Update Figure 33-14

IEEE802.3bt

Sep 2015

Yair Darshan

Option 1:

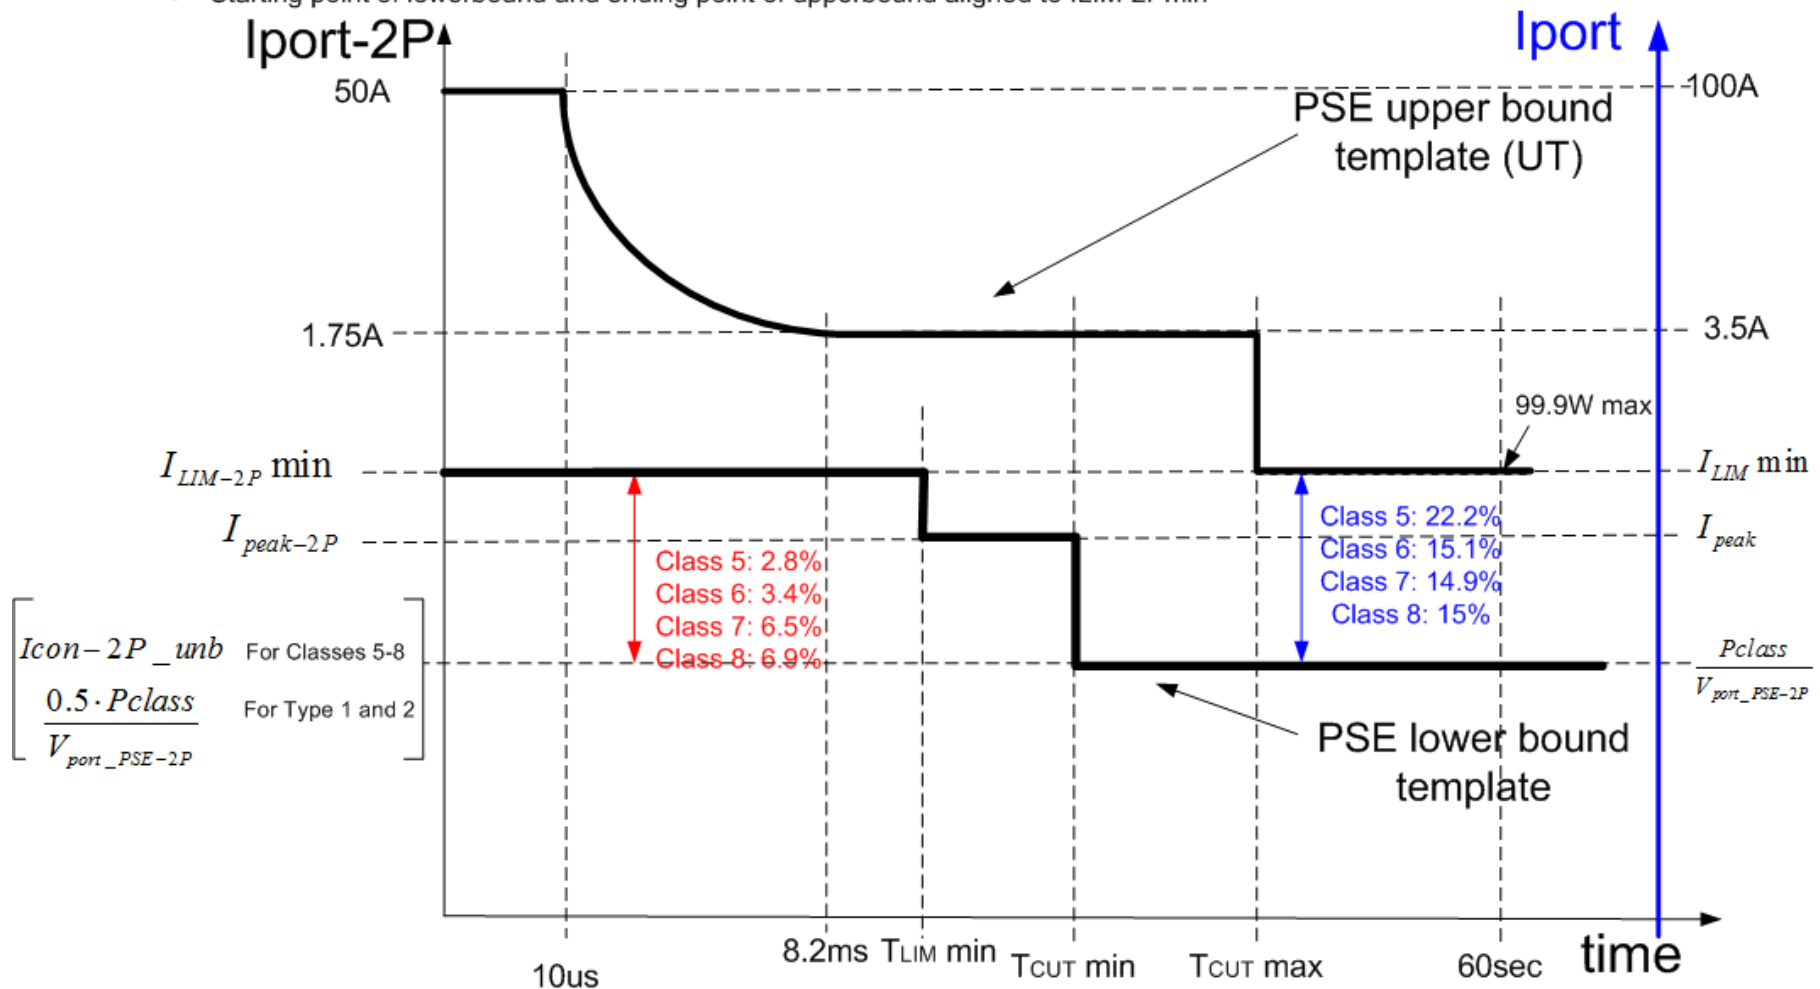
- Single drawing covers all PSE types
- Covers pairset current and total current on different Y axis.
- Starting point of lowerbound and ending point of upperbound aligned to ILIM-2Pmin

Option 2:

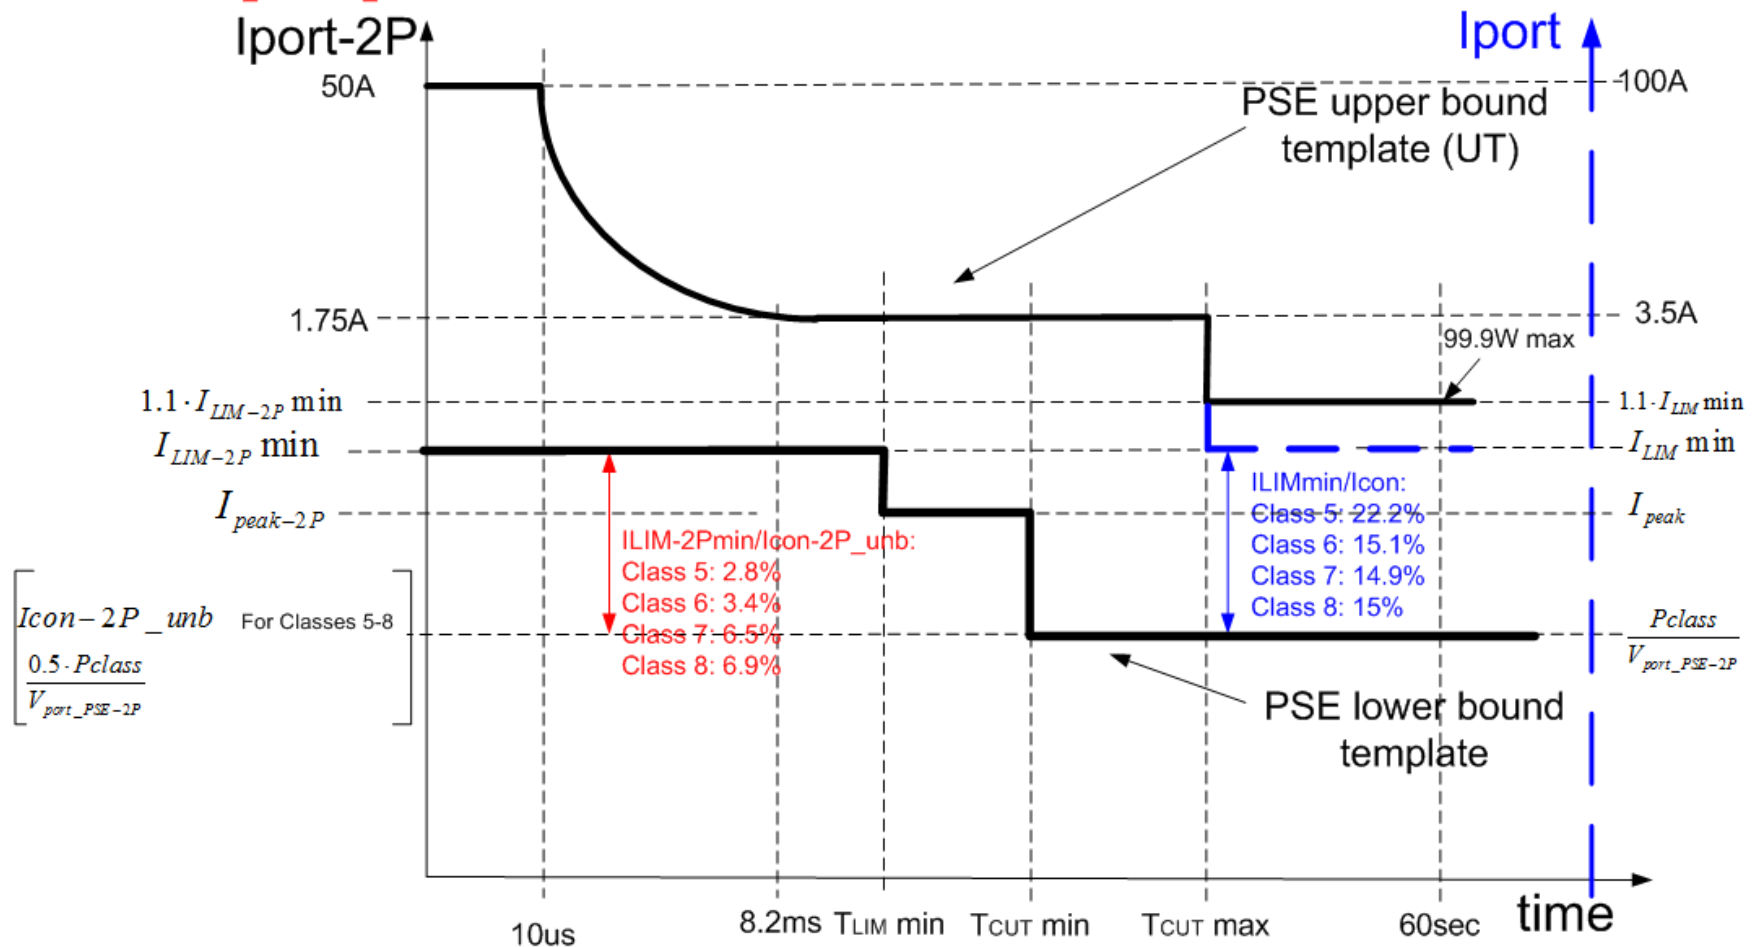
- Single drawing covers all PSE types
- Covers pairset current and total current on different Y axis.
- Starting point of lowerbound (ILIM-2Pmin) and ending point of upperbound has 10% maximum margin on the aligned to ILIM-2Pmin.
- The assumption is that this will not create permission to supply $>ILIM_MIN \cdot VPSE > 100W$ for ever due to the fact that PSE has to police 100W max after T_{cut_max}/T_{lim_max} .
